Comments on the Fast-Track Approval Act 2024 – Matakanui Gold Limited – Substantive Application for the Bendigo-Ophir Gold Project

Our property¹ is mentioned in Matakanui Gold Limited - Substantive Application for the Bendigo-Ophir Gold Project (BOGP) - Lodged Document I.04. "Records of Title - Properties Adjacent to the BOGP Consent Area"².

Figure 2-15: Hydrology Features within Proximity of the Bendigo-Ophir Gold Project

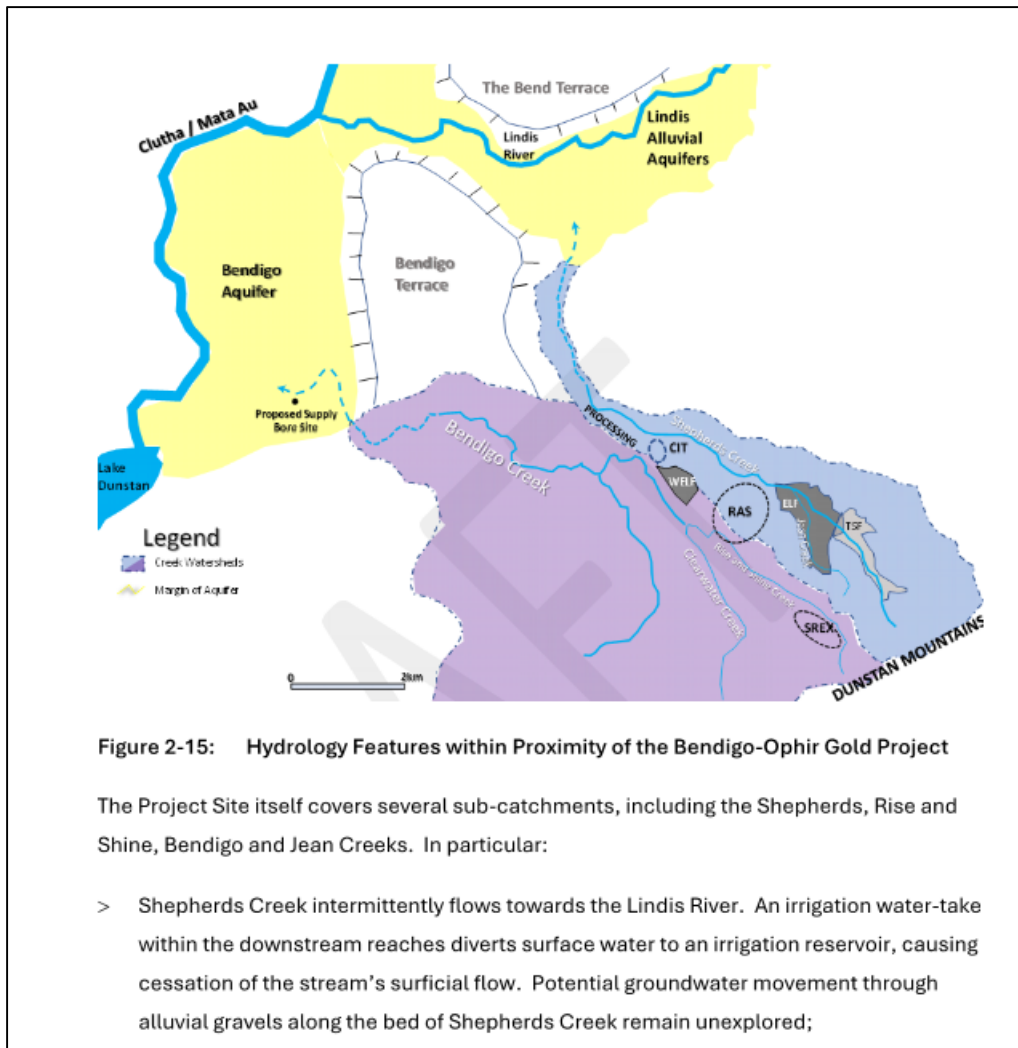
In the very few areas where the aquifers are mentioned, the lack of knowledge about them is acknowledged. The applicant itself states “...groundwater movement through the alluvial gravels along the bed of Shepherds Creek remain unexplored.” Disconcertingly no further investigation is suggested.

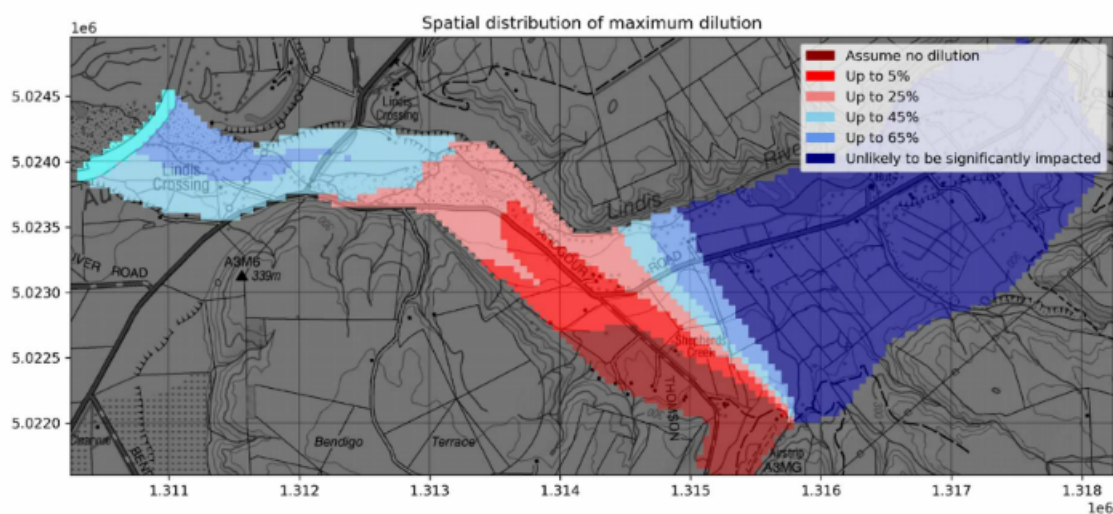
The applicant has provided some guidance using a **generic** model of the movement of water in the LRA and AA. The example of sulphur is used in the discussion, where the proposed discharge limit of 500 milligrams per litre would dilute to 275 mg/l at the Clutha/Mata-au confluence. This dilution effect of 45% is shown in the 'friendly' light blue colour in the image below - referred as Figure 29. As an aside in this particular example, the water we extract from our well would sit above the water quality guideline of 250 mg/l mentioned in the report.

sulphate is 250 milligrams per litre (Taumata Arowai, 2022). These indications from generic groundwater transport modelling result in the requirement to monitor groundwater composition throughout the baseline, operations and post-closure periods for the possibility that the drinking water standard or water quality target concentration would be approached.

Instead of a generic model, what is required is (in scientific parlance) a **proven** scientific model. This is a model that has been tested and validated through empirical data from the site (such as pump tests or tracer studies) to accurately reflect the transmission rates of the LRA and AA, rather than relying on theoretical assumptions. This will create a more accurate assessment so that the transmission and dilution rates of the actual aquifers can be more fully understood.

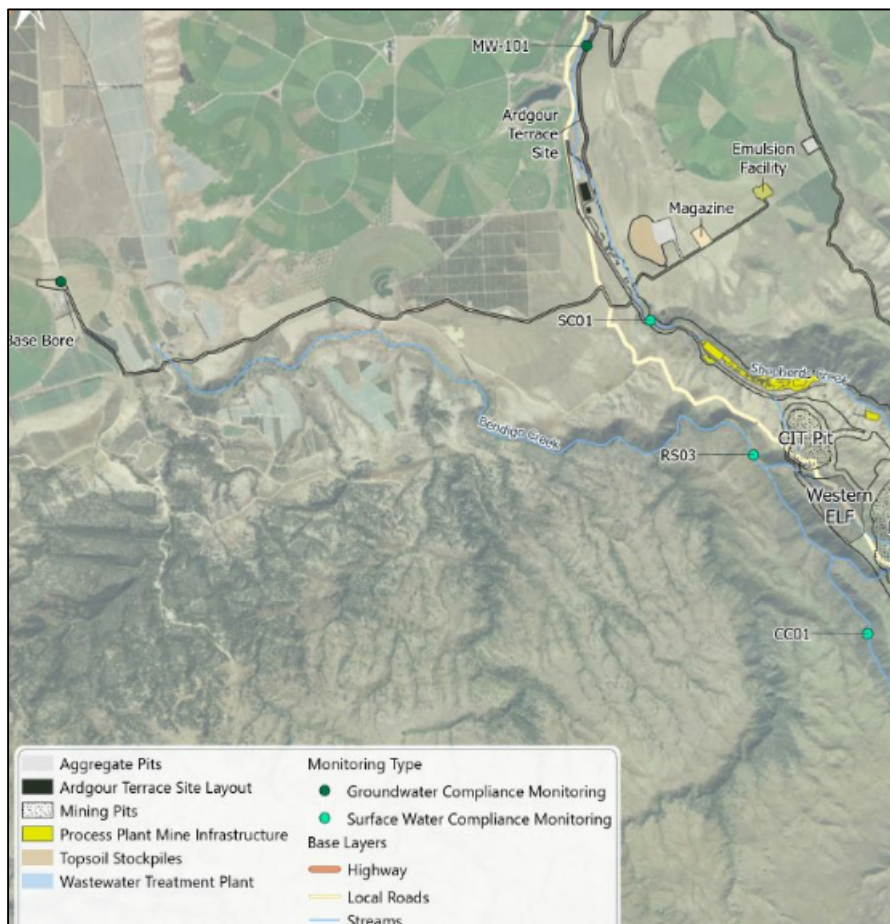
Surface water quality monitoring at the Shepherds Creek, Rise & Shine and Clearwater Creek sites are projected to be done monthly. This is not of sufficient regularity. Should an event occur, it may be up to a month before any environmental damage is detected and any remedial work started. Monitoring sites should also be

required at various points along the Lindis River to ensure the water system is safe for recreation and for animal and human consumption.

B.21 Engineering Geology Limited– Shepherds Tailing Storage Facility

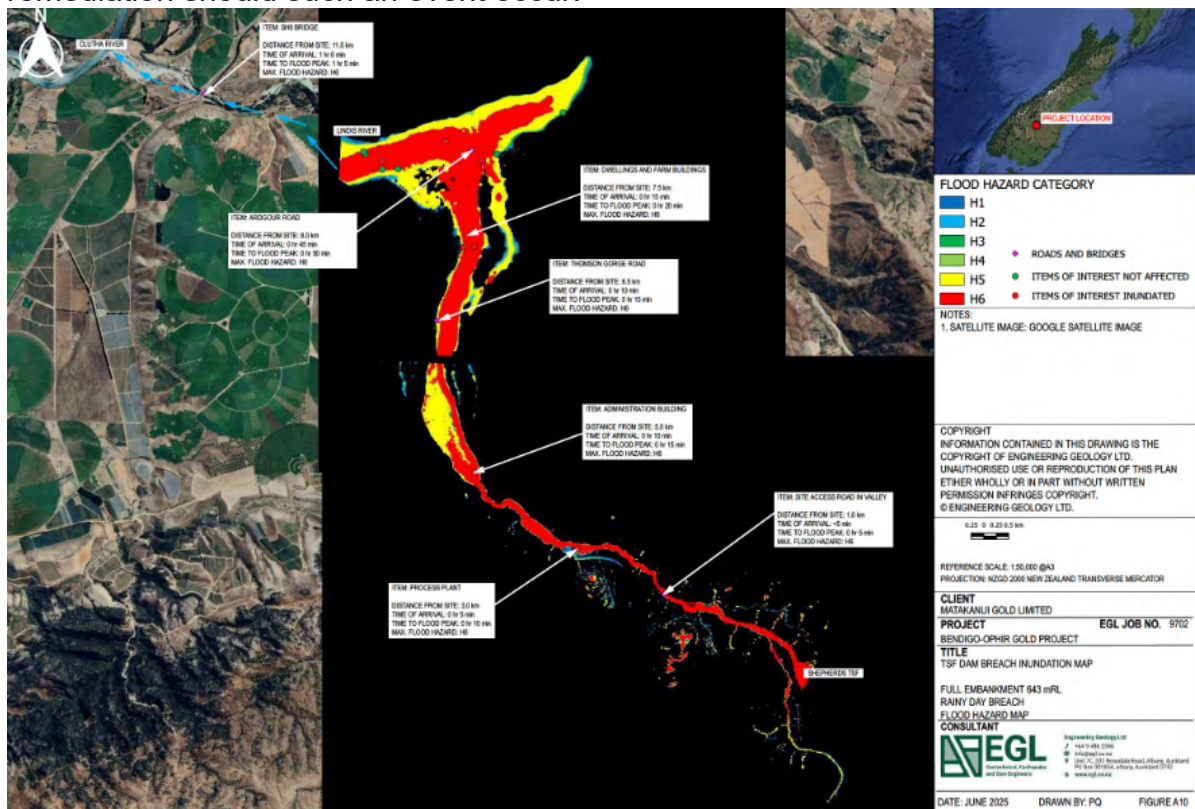
The images they have modelled show the extent of damaged area. The impact is substantial and dramatic. There is no report detailing plans and approaches for remediation should such an event occur.
